DUKE POWER COMPANY

November 16, 1984

Subject: McGuire Nuclear Station
Docket Nos. 50-369 and 50-370
McGuire 2/Cycle 2 OFA Reload

Proposed McGuire Unit 1 and 2 Technical Specification Changes

FIGURE 3.2-2b
 $K(z)$ - NORMALIZED $F_Q(z)$ AS A FUNCTION OF CORE HEIGHT (UNIT 2)

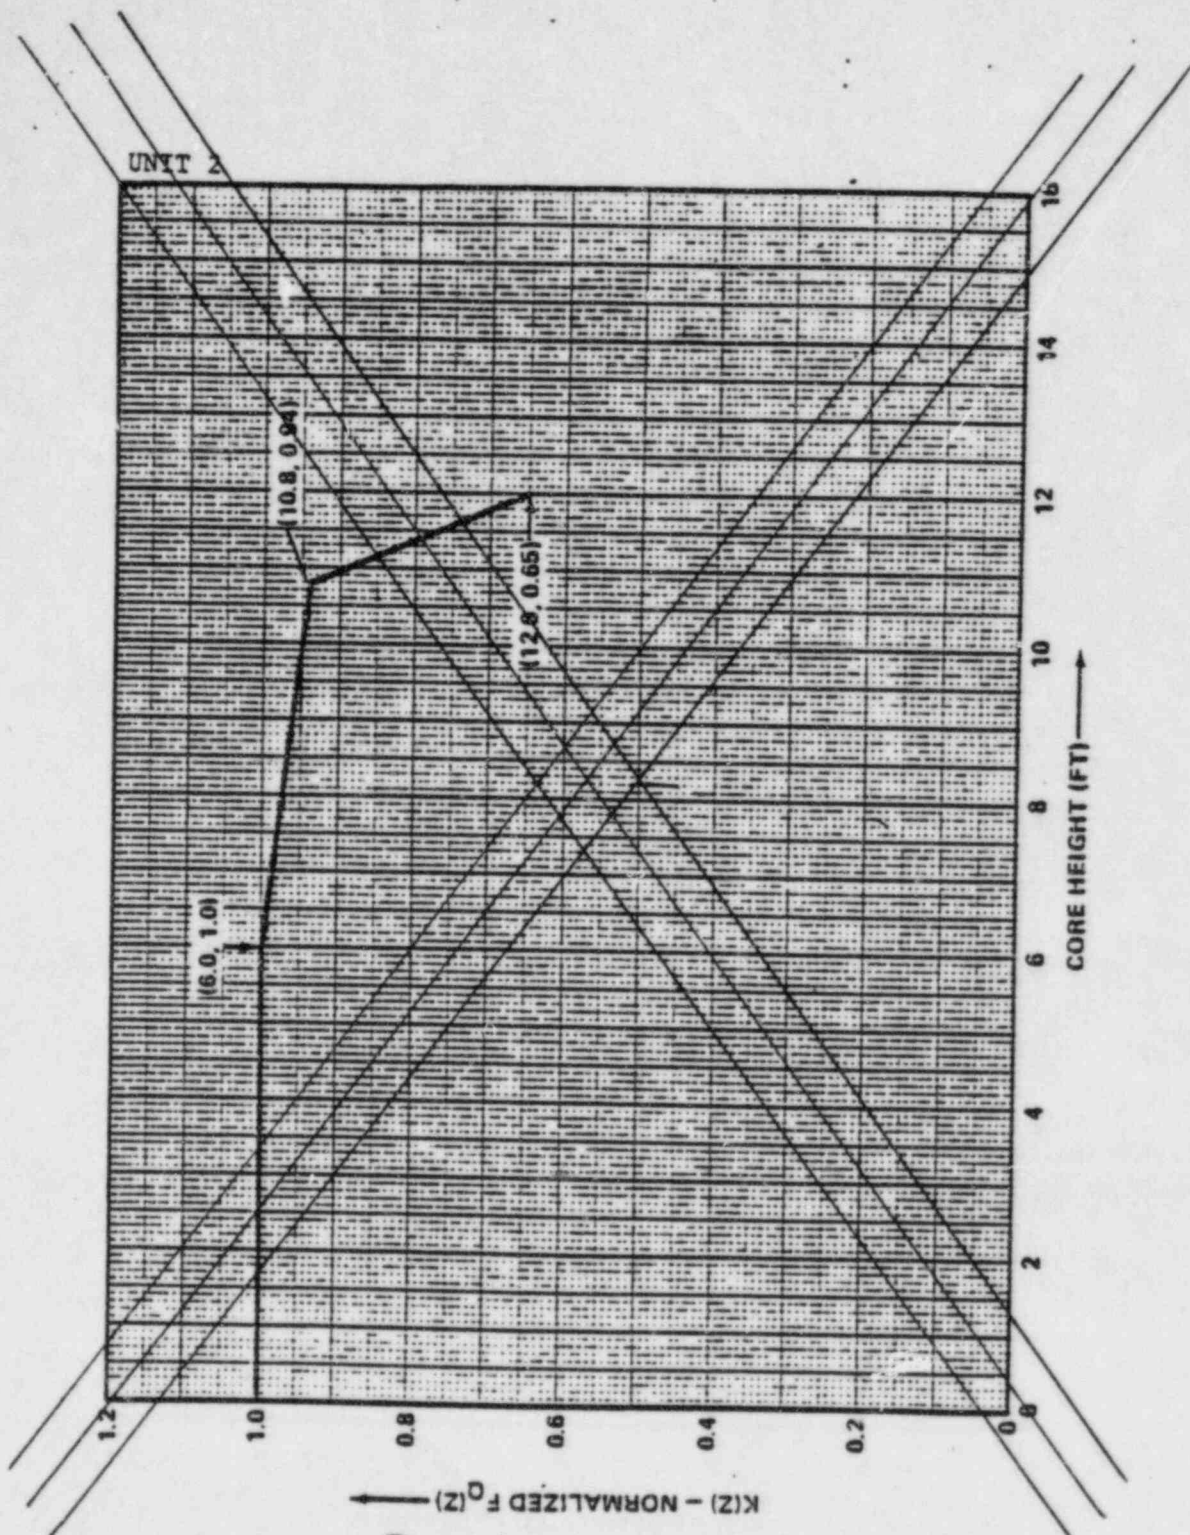
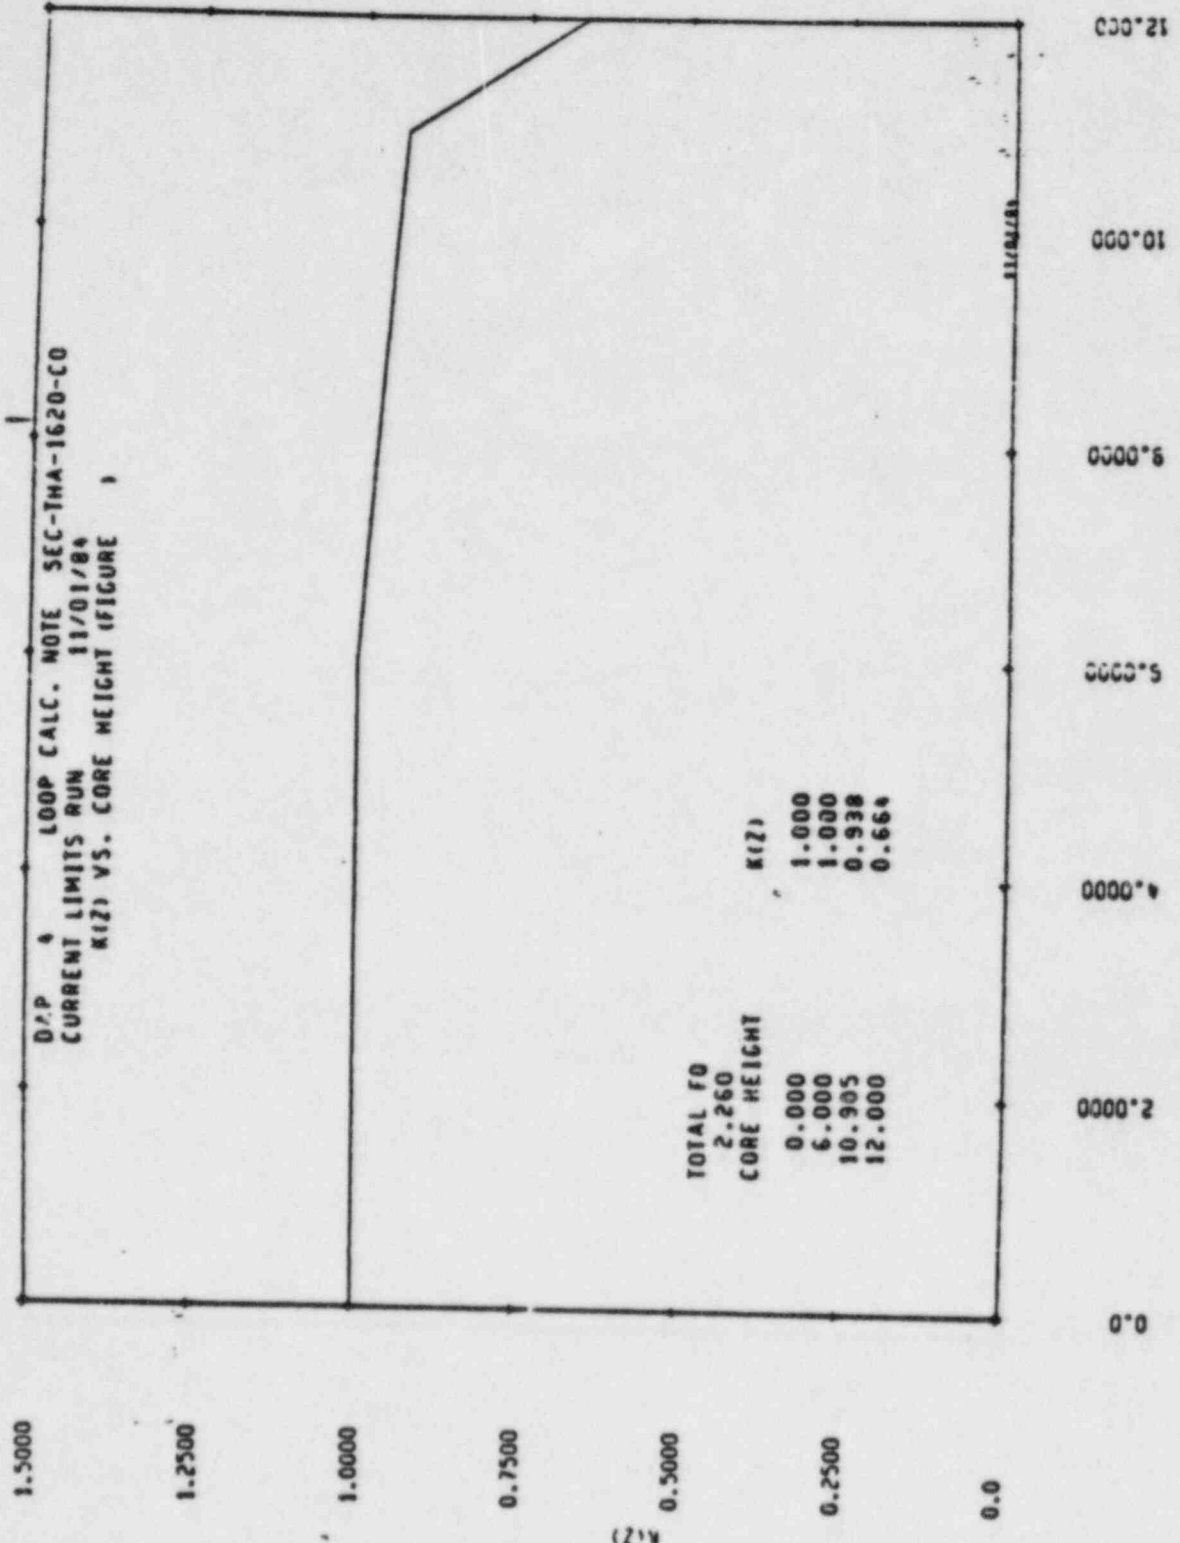
Replace with
 following

FIGURE 2.1-1b
UNIT 2

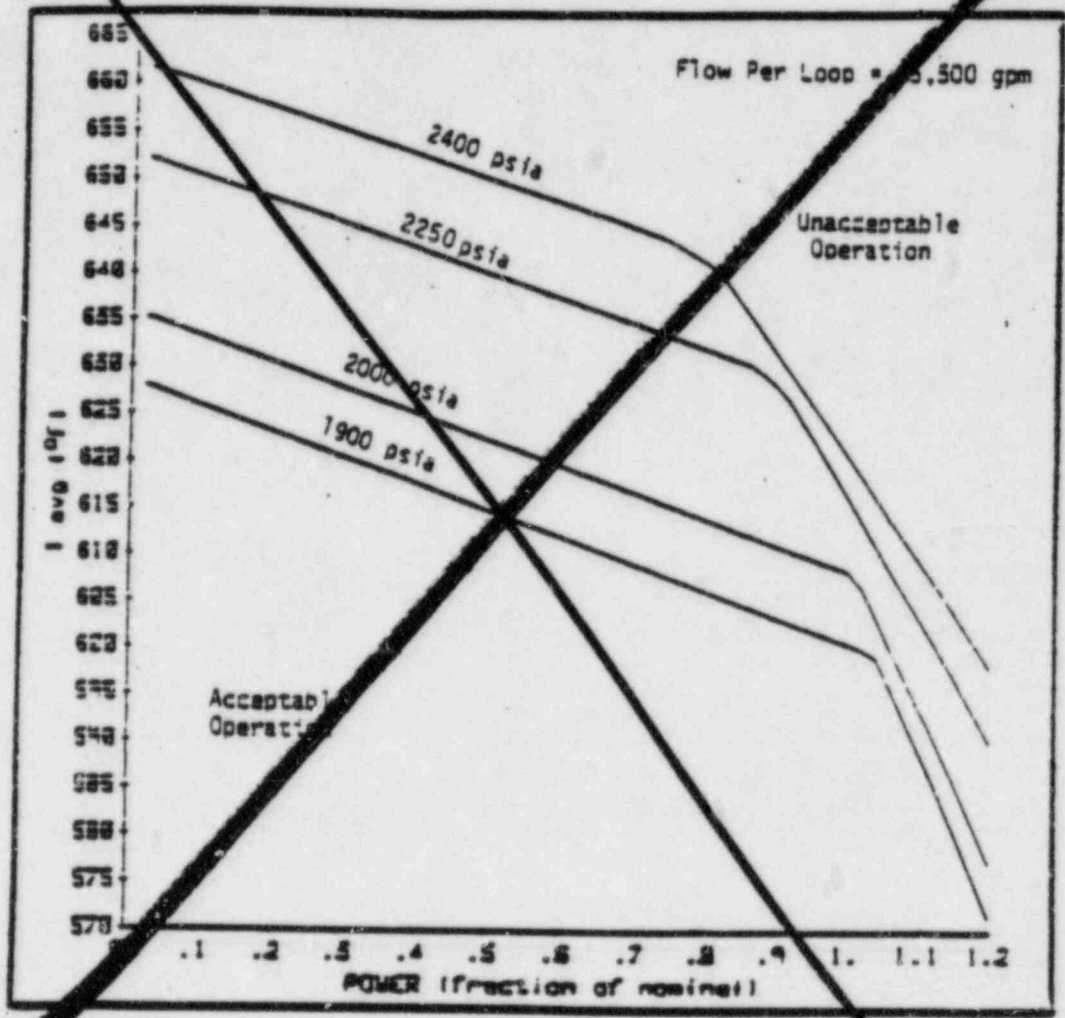
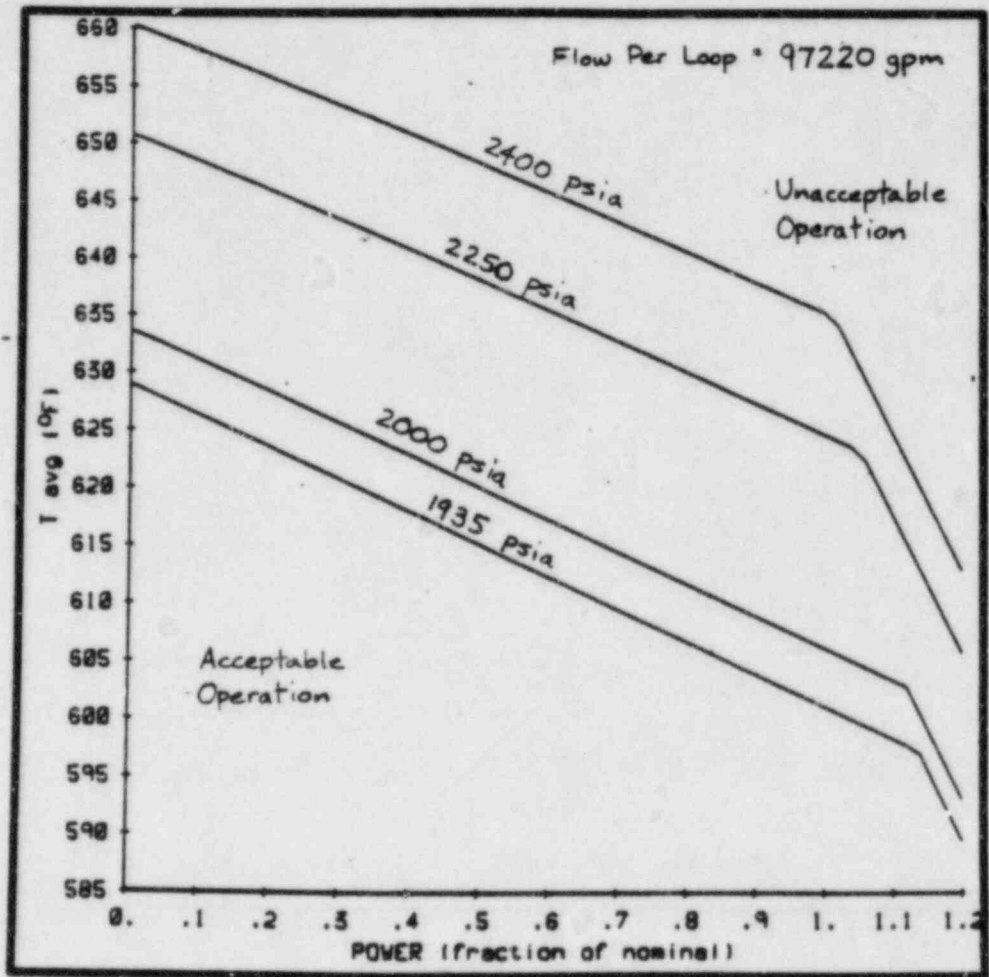
Replace with following

FIGURE 3.2-4 ROD BOW PENALTY AS A FUNCTION OF BURNUP (Unit 2)

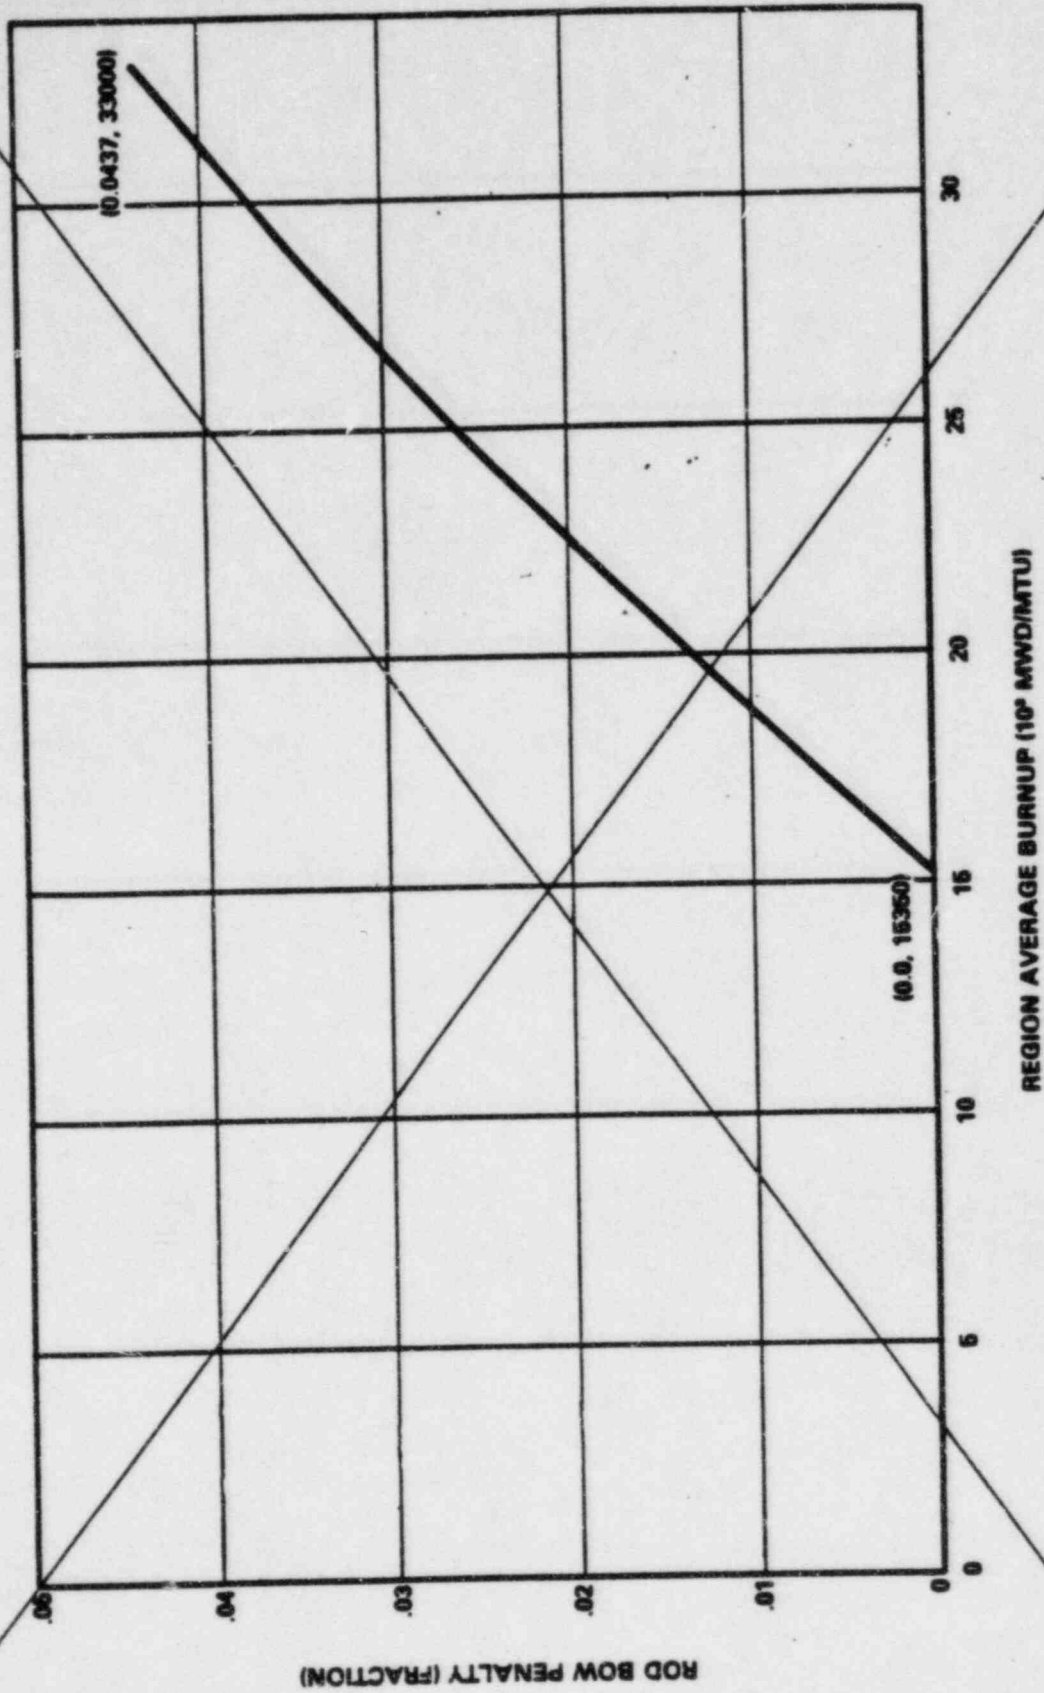
DELETE
